सत्यमेव जयते	प्रसार भारती : PRASAR BHARATI [भारत का लोक सेवा प्रसारक : INDIA'S PUBLIC SERVICE BROADCASTER] Office of the Additional Director General(E)(SZ) AIR &TV Swami Sivananda Salai CHENNAI-600005	 आकाशवाणी
---	--	---

Corrigendum

Sub:- Providing and constructing Profile Sheet Shed for 25KVA DG set at 100W FM AIR, ALLAGADDA, DEVARAKONDA, SIRPUR, RAMAGUNDAM & BHAGALKOT – Reg:-

Ref: Tender Enquiry No: 100W FM TR Project/2022-2023 /IO- 76 Dated 1.12.2022.

II) Existing Drawing in Annexure-I may be read as per Enclosed Revised DG Shed Drawing:

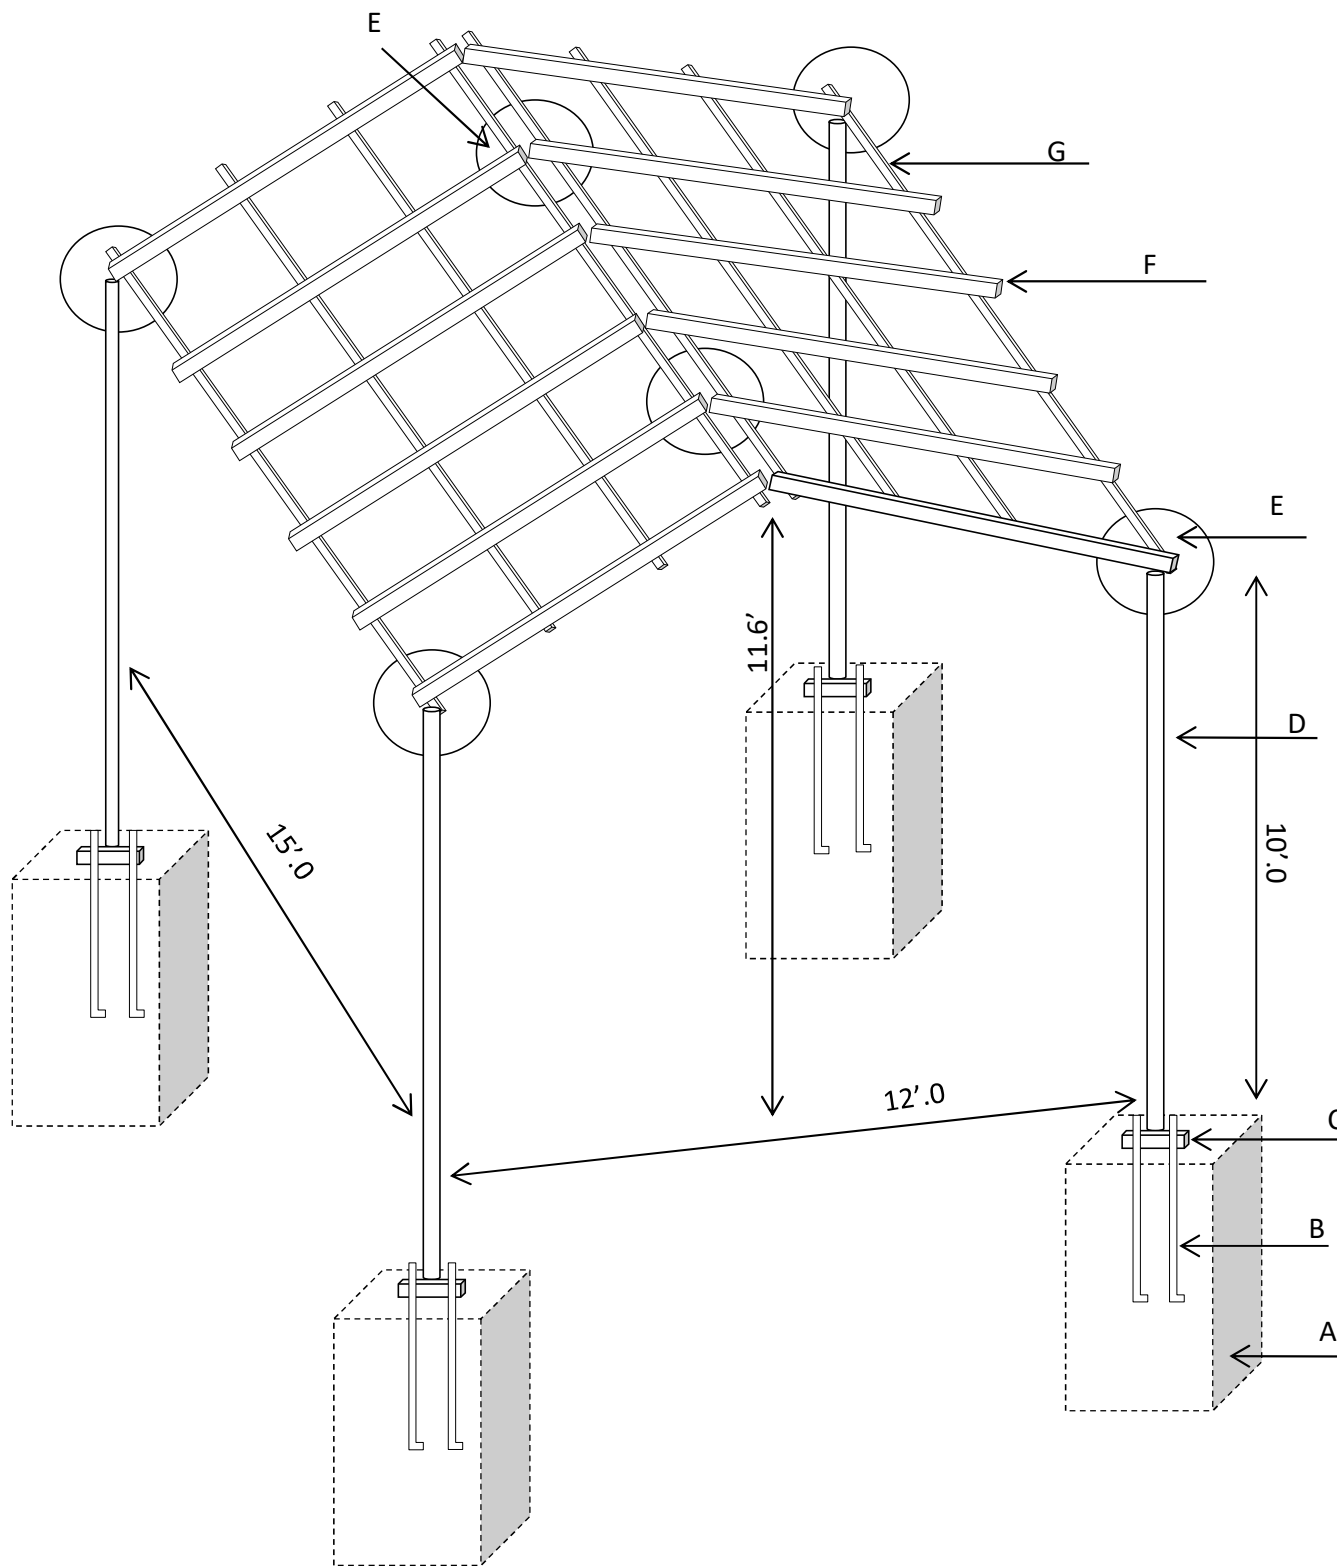
Existing	May be read as
	Description of work	Description of work
1	<p>Providing and constructing sloping Profile Sheet roof Shed for 25 KVA Diesel Generator of size as per enclosed Drawing at Annexure -I for 5 Nos of LPTV/All India Radio stations at 1) Allagadda(AP), 2) Devarakonda, 3) Sirpur, 4) Ramagundam(Telangana) & 5) Bhagalkot(Karnataka) as per following:</p> <p>A) 12' width, 15' Long and height of 11.6' at the centre, sloping on both sides to 10' height at the end as shown in the enclosed Drawing.</p> <p>B) Sloping sides should be given support by matrix of 6 Nos of tubular channels of 3"x 1.5" size and 4 Nos of tubular channels 1.5" x 1.5" size. Tubular channels at the centre has to be joined with 6mm MS Plate fitted with 12mm MS Bolts, nuts & washers.</p>	<p>Providing and constructing sloping Profile Sheet roof Shed for 25 KVA Diesel Generator of size as per enclosed Drawing at Annexure -I for 5 Nos of LPTV/All India Radio stations at 1) Allagadda(AP), 2) Devarakonda, 3) Sirpur, 4) Ramagundam(Telangana) & 5) Bhagalkot(Karnataka) as per following:</p> <p>A) 12' width, 15' Long and height of 11.6' at the centre, sloping on both sides to 10' height at the end as shown in the enclosed Drawing.</p> <p>B) Sloping sides should be given support by matrix of <u>6</u> Nos of tubular channels (<u>thickness: 2mm</u>) of 3"x 1.5" size and <u>8</u> Nos of tubular channels (<u>thickness: 2mm</u>) of 1.5" x 1.5" size. Tubular channels at the centre has to be joined suitably</p>

<p>C) Vertical 4 supports through 3" dia pipe has to be provided at the corners.</p> <p>D) Half curved PVC Pipechannel has to be provided at edge of sloping side to drain out the rain water.</p> <p>E) Four Foundation Bolts at a length of 3 feet with suitable dia for each of Vertical supports shall be dig with 300mm x 300mm x 600mm and filled with 1 : 2 : 3 ratio of concrete mixture. The Poles shall be fitted properly with perfect 90 degree angle from the ground.</p> <p>F) Before fixing the top roof, the entire structure shall be painted with one coat of epoxy metal primer and two coats enamel paint properly.</p> <p>G) Corrugated colour Metal Roofing preferable sky blue colour (Similar to Everest) shall be provided with the 1090mm x 3050mm length with a cover width of 1006mm with thickness of 0.45mm(TCT) and strength as per GL SSOMPA as per AS:1397. The Colour metal roofing sheets shall be fitted with proper Clamp</p>	<p>C) Vertical 4 supports through 3" dia pipe of 2mm thickness has to be provided at the corners.</p> <p>D) Half curved PVC Pipechannel has to be provided at edge of sloping side to drain out the rain water.</p> <p>E) Four Foundation Bolts at a length of 3 feet with suitable dia for each of Vertical supports shall be dig with 300mm x 300mm x 600mm and filled with 1 : 2 : 3 ratio of concrete mixture. The Poles shall be fitted properly with perfect 90 degree angle from the ground.</p> <p>F) Before fixing the top roof, the entire structure shall be painted with one coat of epoxy metal primer and two coats enamel paint properly.</p> <p>G) Corrugated colour Metal Roofing preferable sky blue colour (Similar to Everest) shall be provided with the 1090mm x 3050mm length with a cover width of 1006mm with thickness of 0.45mm(TCT) and strength as per GL SSOMPA as per AS:1397. The Colour metal roofing sheets shall be fitted with proper Clamp</p>

A— 12"by24" pit filled by cement concrete with 15"*1/2" foundation bolt.

B— 15"*1/2" G.I bolt,nut with plate washer and spring washer.

C— 6.0"*0.25" ms plate suitable hole welded with 3.0" ms pipe. [D]

D— 10'.0*3".0*2mm,ms pipe. 4nos

E— The tubuler section and pipe should be joint by 12mm bolt and nut, with welded 6mm ms plate.Both side.[removable method]

F—3" * 1.5" * 2mm ms tubuler channel.

G—1.5" *1.5" * 2mm ms tubuler section.
